AMERICAN SUZUKI MOTOR CORPORATION

07V-554
(25 Pages)

RE: 2006 & 2007MY Grand Vitara (E28/E33) Safety Recall Campaign of AT Selector Assy for North American markets

SUBJECT: SAFETY RECALL CAMPAIGN "PE", SHIFT LOCK SOLENOID REPLACEMENT

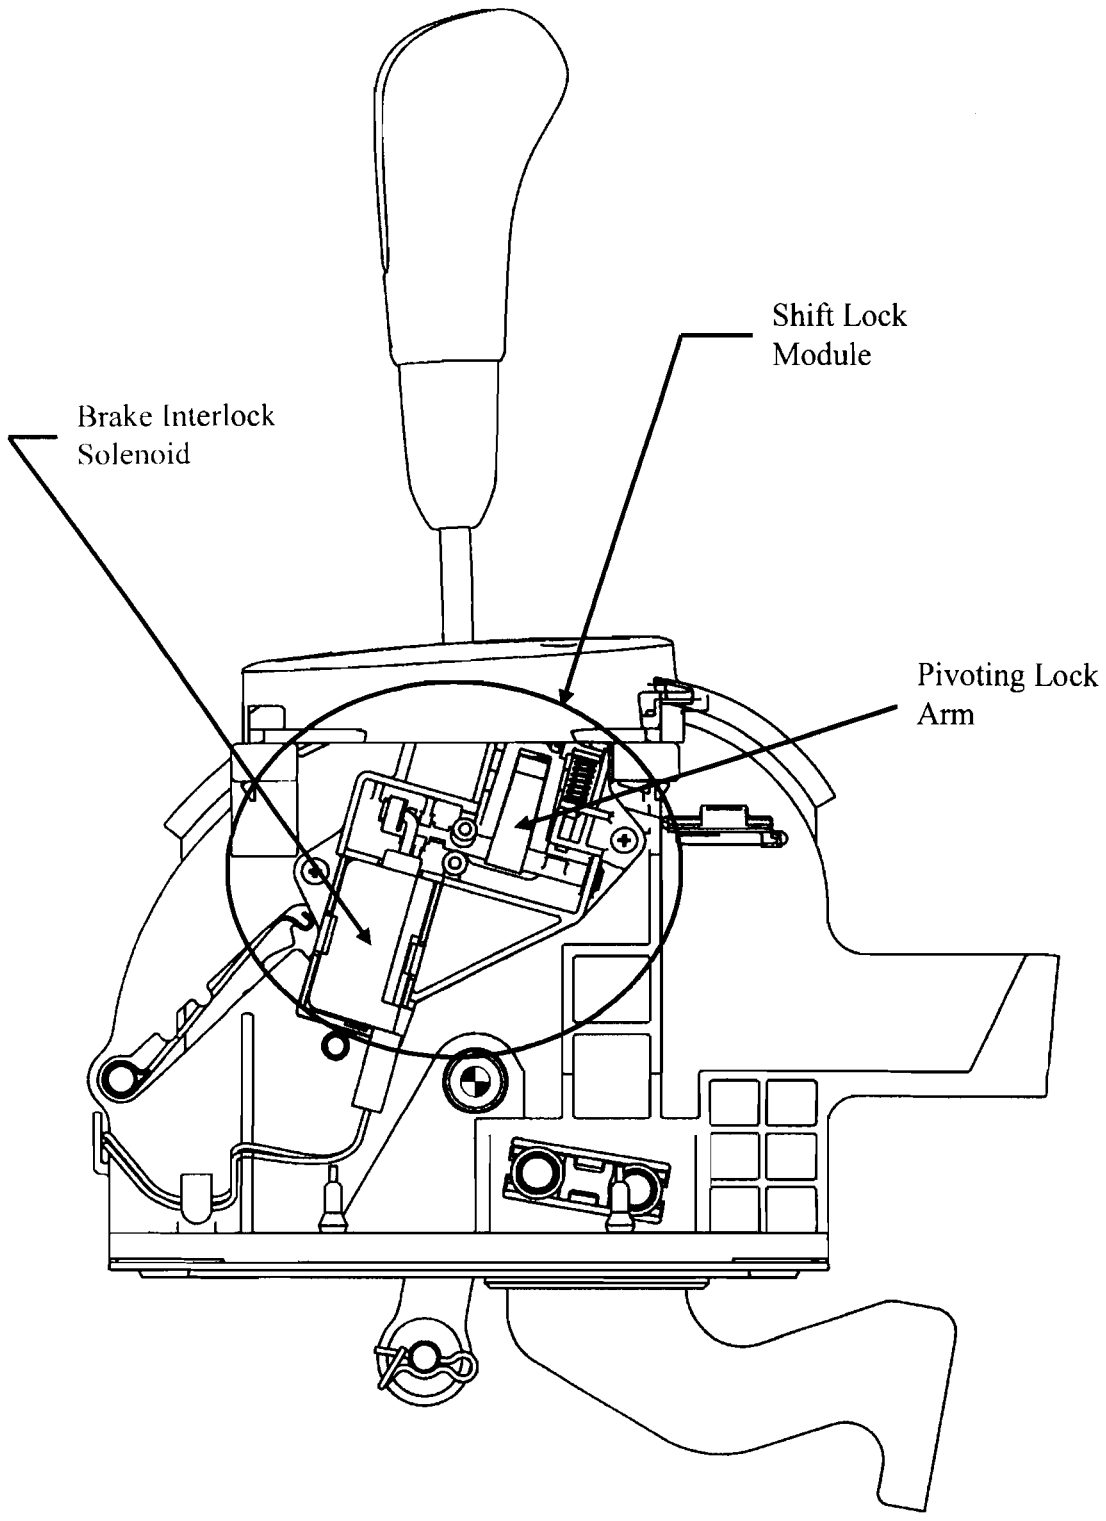
Some affected vehicles may fail to conform to Federal Motor Vehicle Safety Standard No. 114, *Theft protection*. The mechanism that locks the automatic transmission shift lever in the "Park" position consists of a pivoting lock arm that is connected to a solenoid valve plunger that moves upward to pivot the lock arm to the "lock" position when the transmission shift lever is in "Park" and the service brake is released. Refer to the attached illustration. The shape of the bushing that is used to connect the solenoid plunger and pivoting lock arm, in combination with certain component part installation orientations, can cause the lock arm to become stuck, and fail to pivot to the "lock" position when the shift lever is in "Park" and the service brake is released. As a result of this condition, the shift lever will be able to be shifted out of "Park" with the key removed and without depressing the brake pedal.

Suzuki distributors will conduct a safety recall campaign to replace the shift lock module on the shift lever assembly of affected vehicles. Since some 2007 model year vehicles may have been produced with shift lever assemblies that contain the improved bushing (which can be easily recognized), an inspection of affected 2007 model year vehicles will be conducted to determine the need for repair.

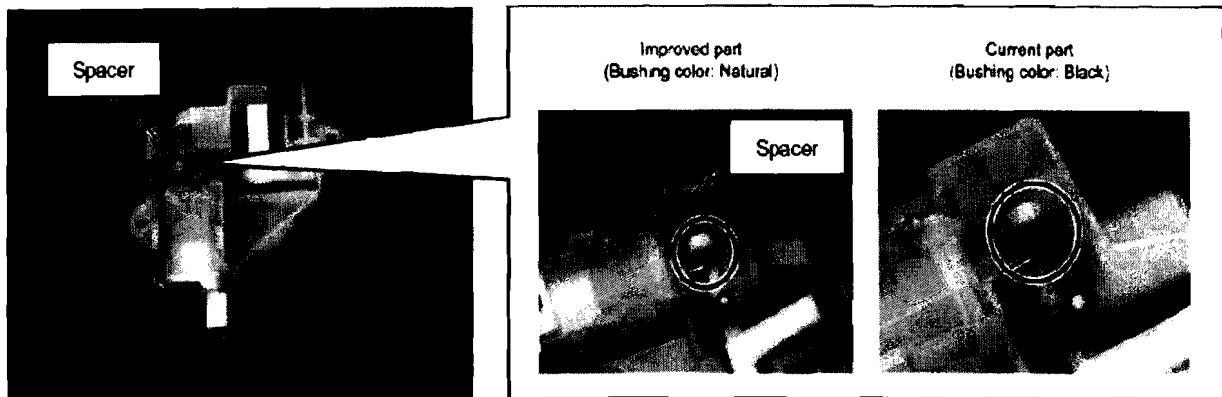
CONDITION: On affected vehicles, the automatic transmission shift selector lever parking lock function may be inoperative due to a sticking shift lock solenoid plunger. As a result, the shift lever will be able to be shifted out of "Park" with the key removed and without depressing the brake pedal.

CAUSE: Pivot bushing may bind at solenoid plunger

CORRECTION: Replace the shift lock solenoid assembly on any new, as well as in-stock used and customer vehicles regardless of vehicle age or mileage within the affected VIN range. See instructions below.

The improved part is distinguished by color of the bushing.

NOTE: Remove spacer after installation.

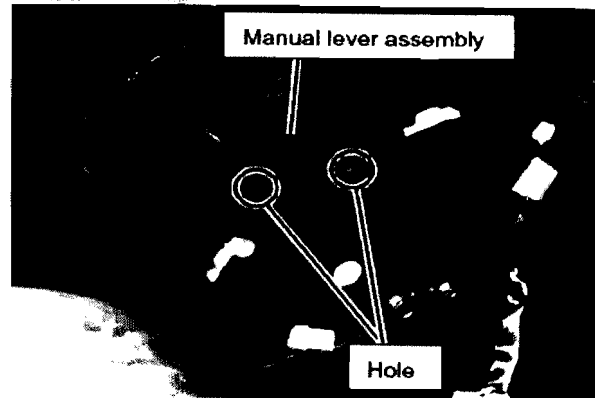
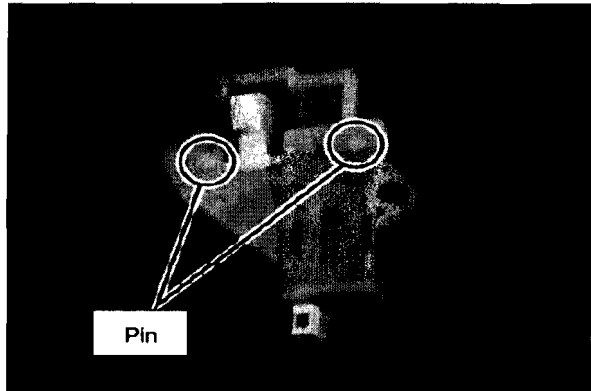
11. Remove two screws and connector first, and then remove shift lock unit assembly (current part) from manual lever assembly.

12. Install shift lock unit assembly (improved part) to manual lever assembly

13. Remove spacer from the shift lock solenoid after installation.
14. Re-assemble center console in reverse of removal procedure.
